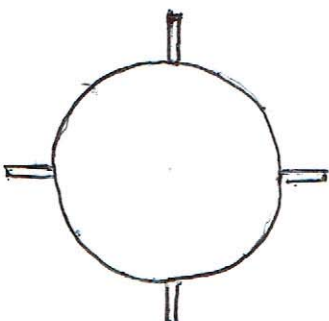
IS THE STIFFENER TO STACK
WALL LOCATION SUSCEPTIBLE
TO ADDITIONAL LOCAL
BUCKLING STRESSES?
